**LONDO FORBES CREEK**

Kirkland, Washington

Subject: Response to Peer Review Comments  
Londo Forbes Creek  
20<sup>th</sup> Avenue and 4<sup>th</sup> Place  
Kirkland, Washington

**SLOPE STABILITY - EXISTING  
CROSS-SECTION C - C' SEISMIC  
LONDO FORBES CREEK  
KIRKLAND, WASHINGTON**

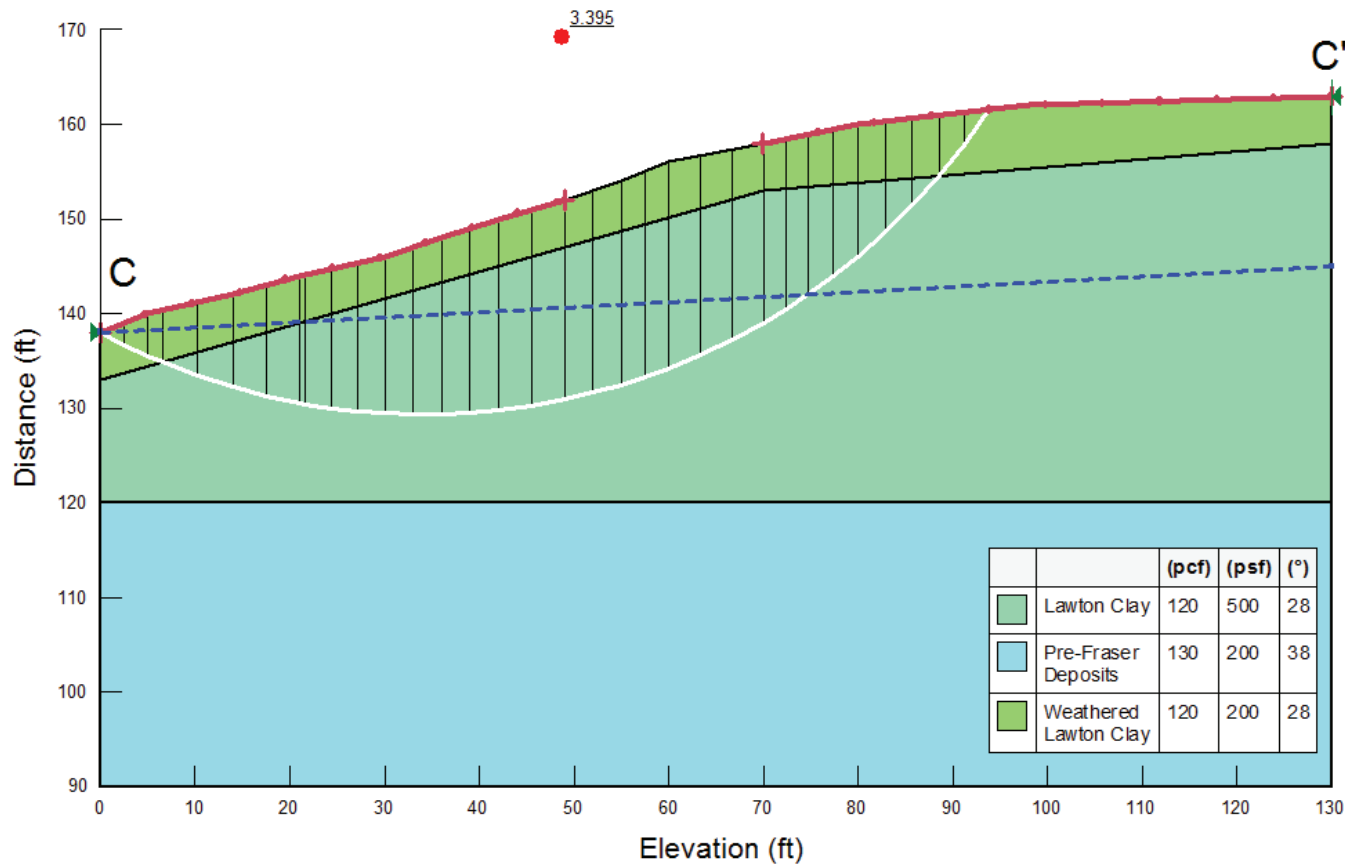
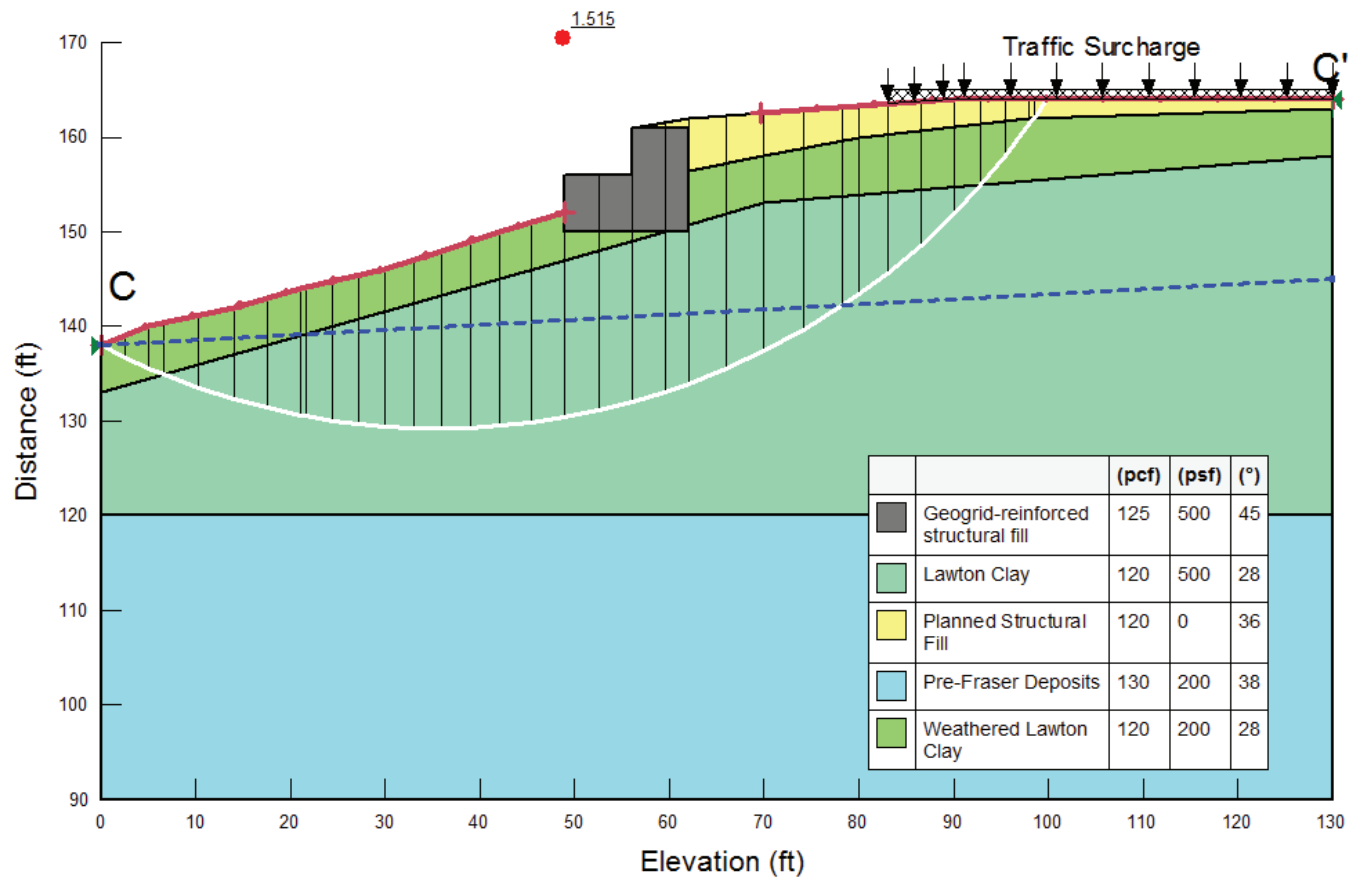
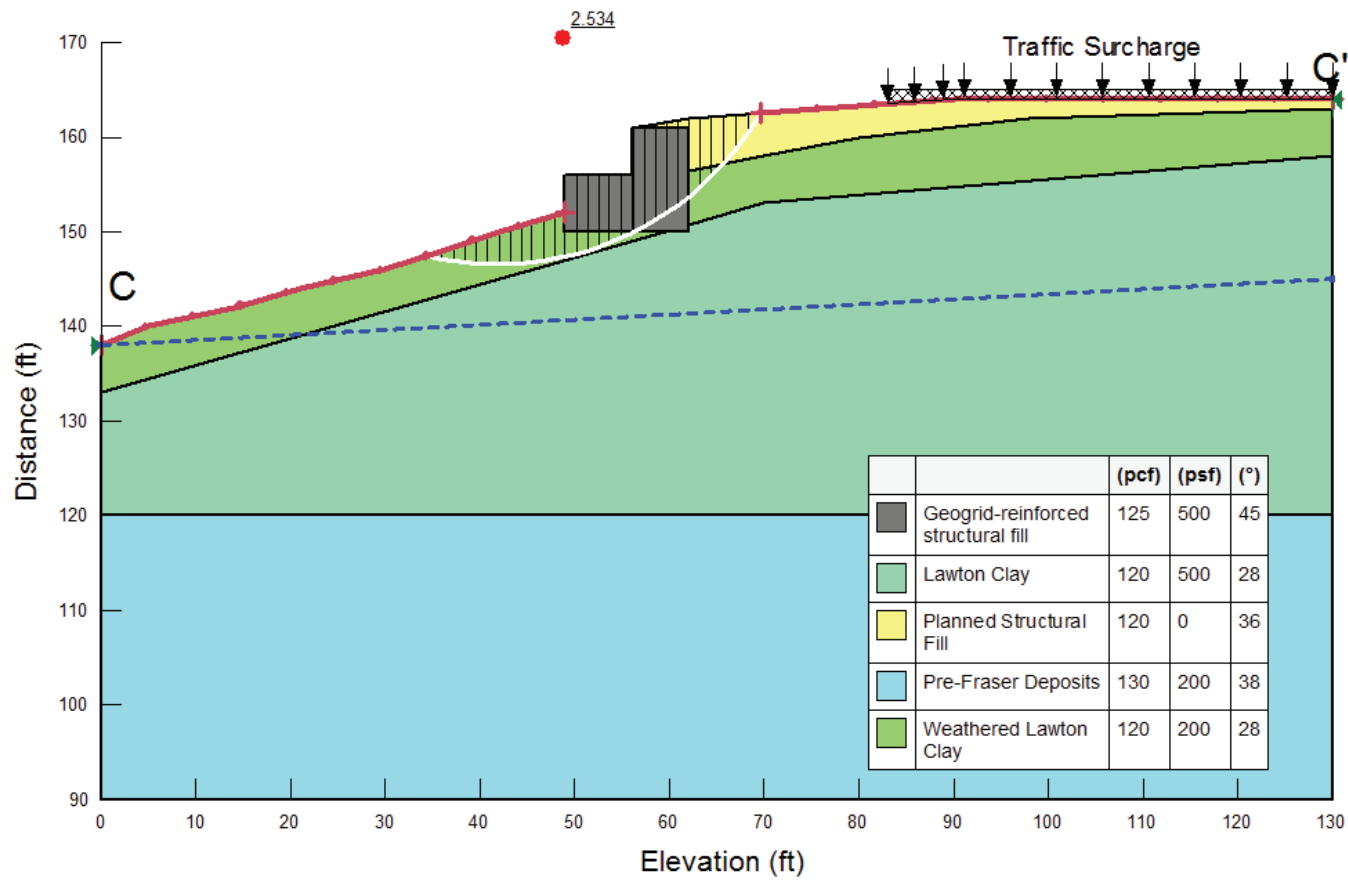
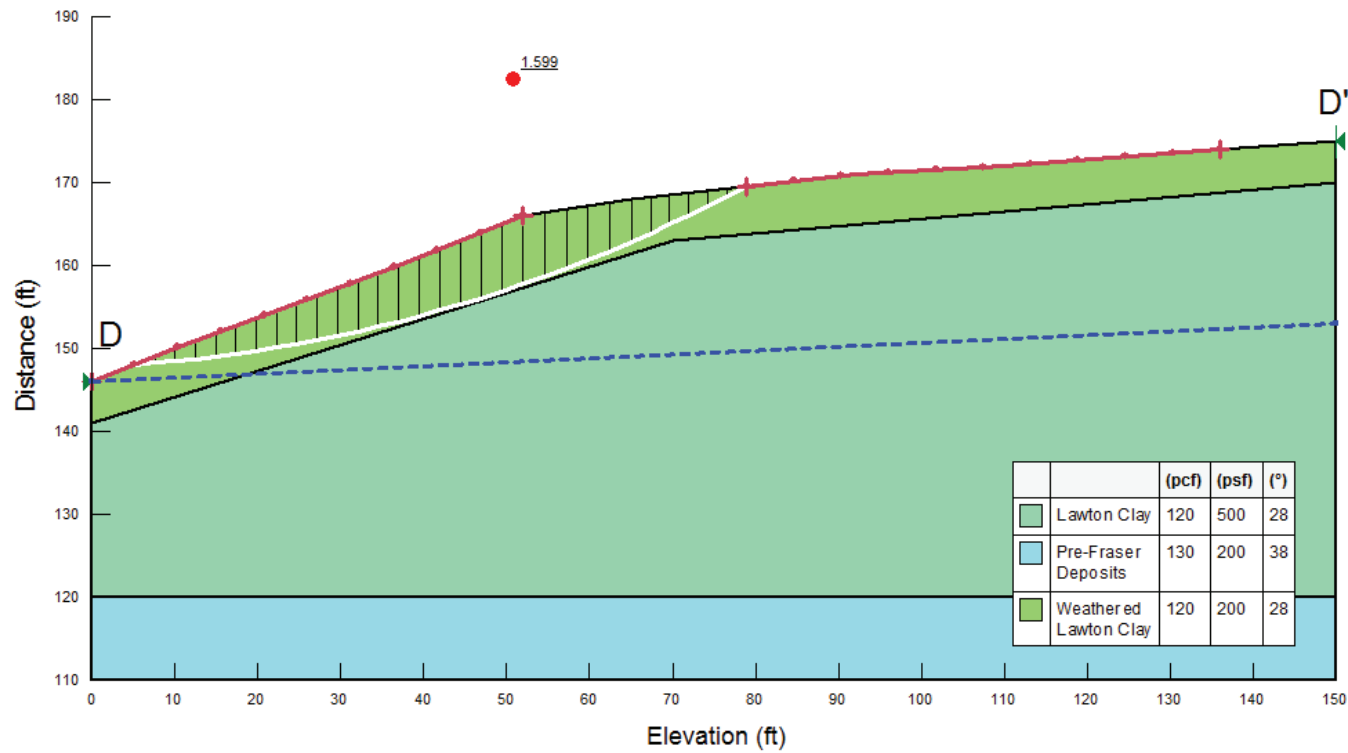
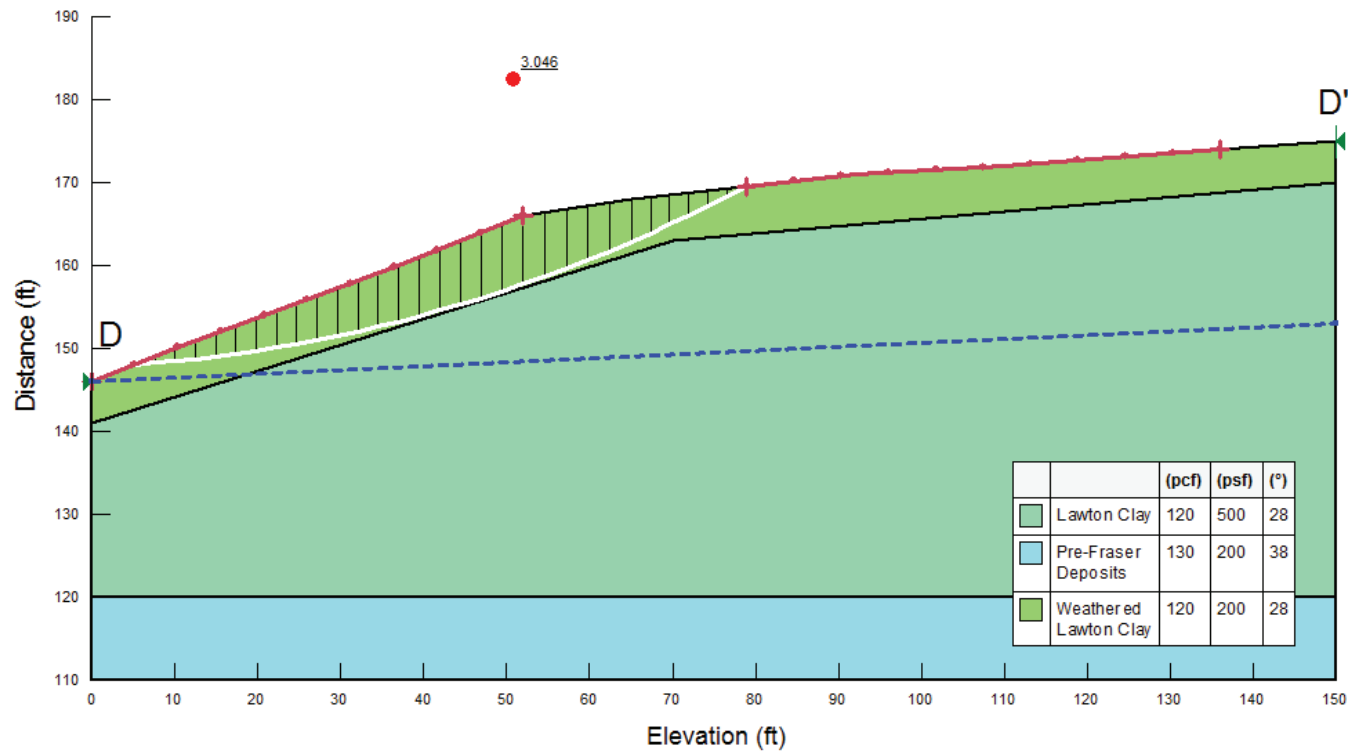
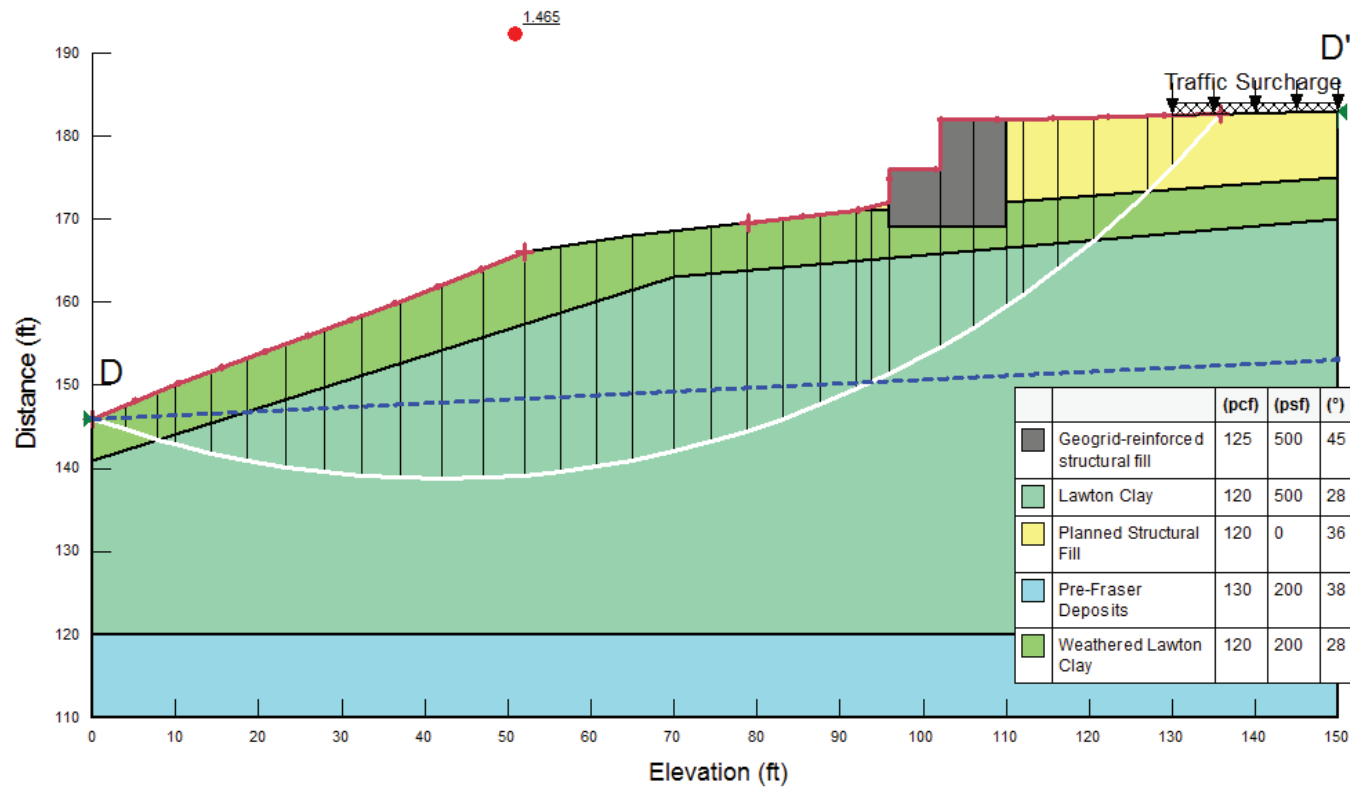
**KZC 85.15 #4, a** - *Slope stability analyses of the existing site conditions are also required to verify how the proposed grading will impact existing slope stability.*

Using the soil parameters presented in our February 20, 2018 report, we completed slope stability analyses of existing and proposed site conditions along Cross-Sections C-C' and D-D', shown on the attached “Site and Exploration Plan” (revised from “Figure 2” of our February 20, 2018 report). Soil strength parameters used for our analysis, along with interpretive geologic cross-sections and critical slip surfaces calculated under both static and seismic conditions, are shown on the attached figures. A traffic surcharge of 250 pounds per square foot (psf) was used for our analysis of planned conditions where parking areas are proposed. The resulting factors of safety for slope movement for both existing and proposed conditions along the modeled cross-sections exceeded 1.50 under static conditions and 1.15 under seismic conditions.
